Botley West Solar Farm

Appendix 4.2: Scoping Opinion

Issue of Scoping Opinion and list of the consultation bodies notified by the Secretary of State

Adopted by the Planning Inspectorate (on behalf of the Secretary of State) pursuant to Regulation 10 of The Infrastructure Planning (Environmental Impact Assessment) Regulations 2017

Figure 1
 showing 'Botley West' in dark blue, the most likely alternate location of the 440kV National Grid substation in light blue, and the perimeter of the proposed Red House Farm solar power station in red

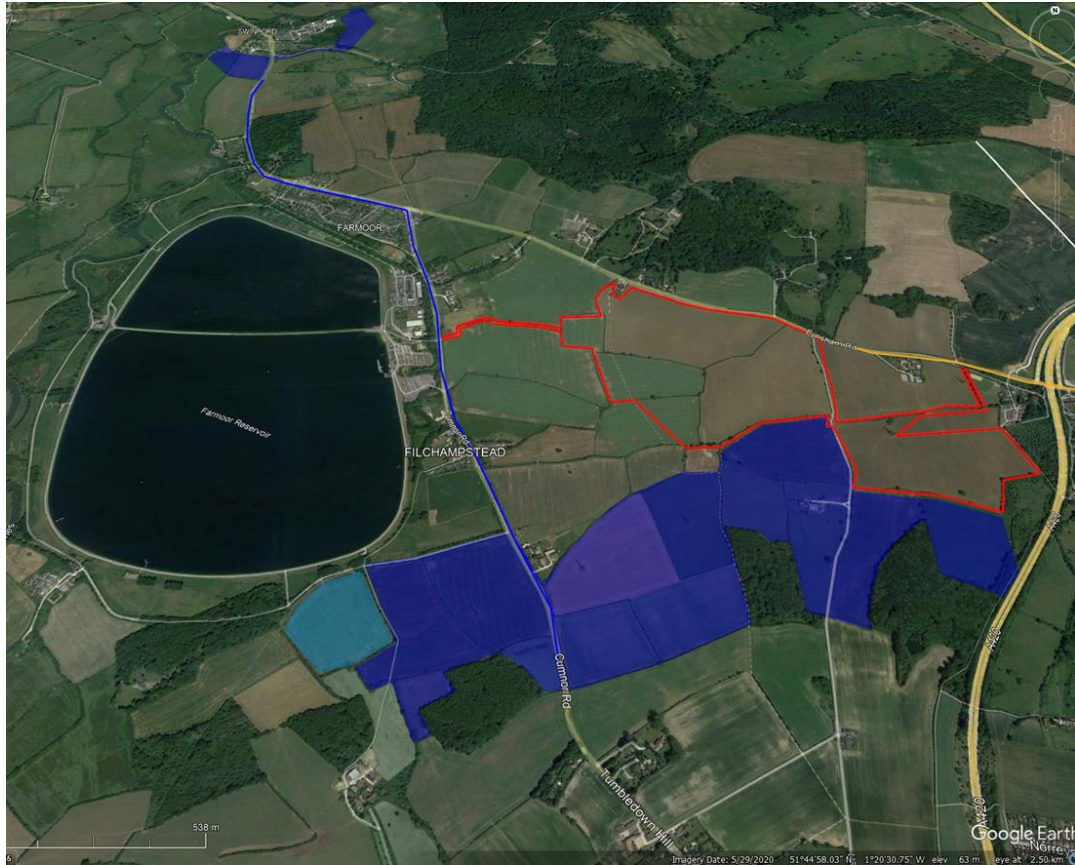
Council draws PINS attention to the fact that the proposed southern site lies immediately adjacent to, and south of, another proposed solar power station (Red House Farm – see Figure 1 below) where the Vale of White Horse District Council (VWHDC) has required an extensive set of Environmental Impact Assessments be carried out ([P22/V2581/SCO](#)).

Figure 2

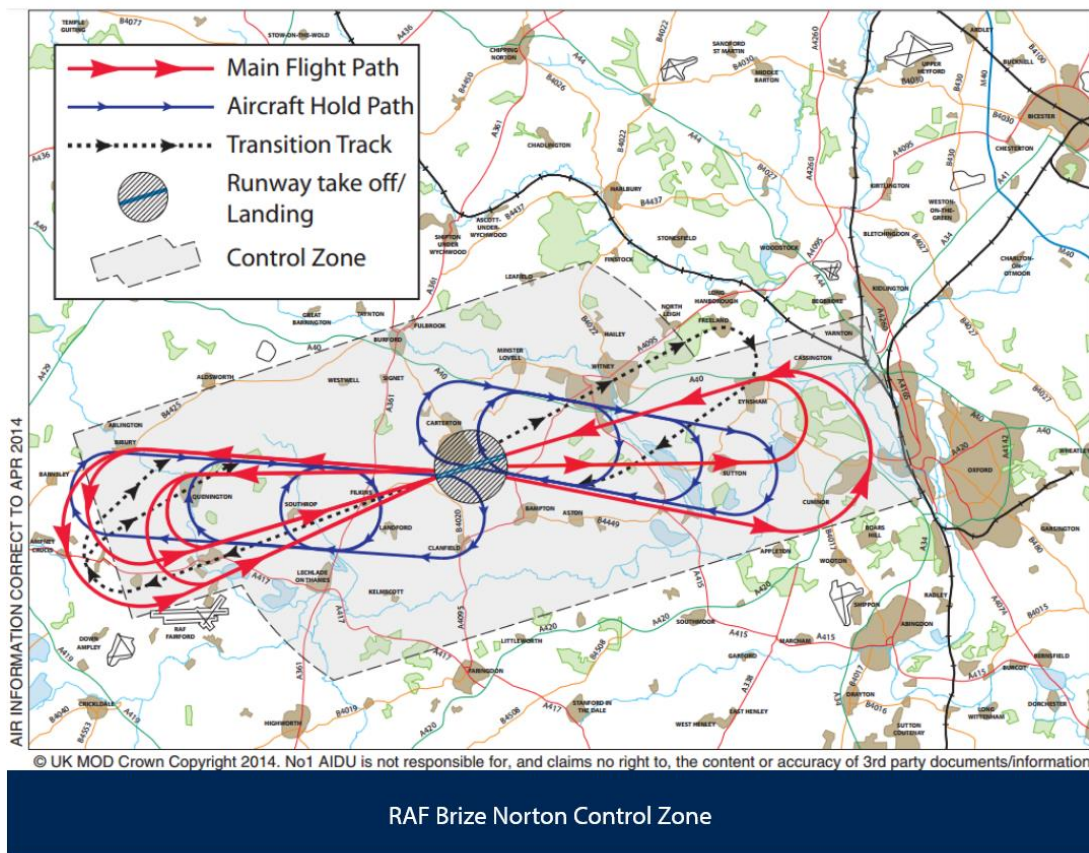
Council requests that RAF Brize Norton (to the west of the central and southern sections, with the southern section being on the designated flightpath) should be included (para 8.3.14) – see also Figure 2 below.

Recent, well publicised fires in solar power stations in the UK and overseas point to the necessity of applying the precautionary principle here, particularly as the site is just a km or so to the west of Oxford and will be within 60m of Thames Water's Farmoor reservoir (14 million litres, supplying Swindon etc.), and which lies directly under the RAF's flight path, and within the Control Zone, for RAF Brize Norton (see [Figure 2](#) below).
